RESUBDIVISION OF LOT 11, BLOCK C, GLEN ACRES **SUBDIVISION, FIRST ADDITION**

The plat illustrates the proposed 2-lot, 0.9± acre subdivision which is located at 1301 Wilkins Street and 8903 Glen Acres Drive North (Southwest corner of Wilkins Street and Glen Acres Drive North). The subdivision is served by public water and individual septic tanks.

DETAIL SITE PLAN

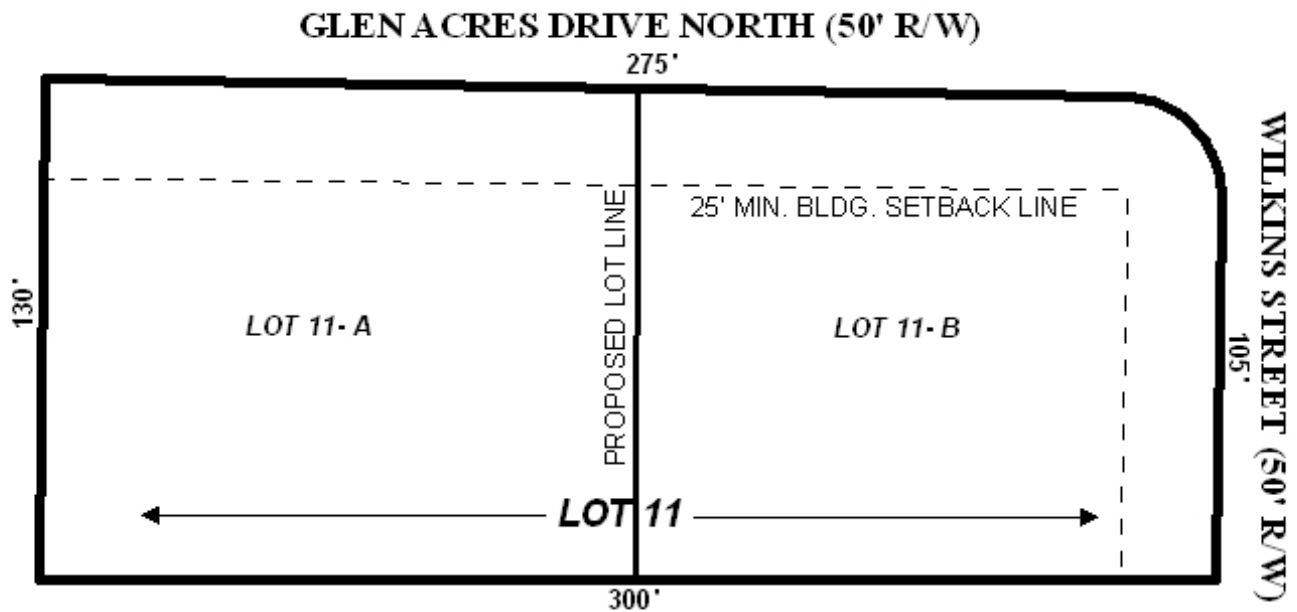
The plat illustrates the 25-foot minimum building setbacks on all street frontages.

Given the amount of street frontage, both of the proposed lots should be limited to one curb cut. The proposed Lot 11-A should be limited to one curb cut to Glen Acres Drive North, and the proposed Lot 11-B should be limited to one curb cut to Wilkins Street, with the size, design, and location of all curb cuts to be approved by Mobile County Engineering.

The plat should show the size, in square feet, of each lot, or a table with the same information should be provided.

- 1) provision of a note on the final plat stating that Lot 11-A is limited to one curb cut to Glen Acres Drive North, and Lot 11-B is limited to one curb cut to Wilkins Street, with the size, design, and location of all curb cuts to be approved by Mobile County Engineering;

- 2) labeling of each lot with the size, in square feet, or provision of a table with the same information;
- 3) provision of a note on the final plat stating that any lots which are developed commercially and adjoin residentially developed property must provide a buffer, in compliance with Section V.A.7. of the Subdivision Regulations; and
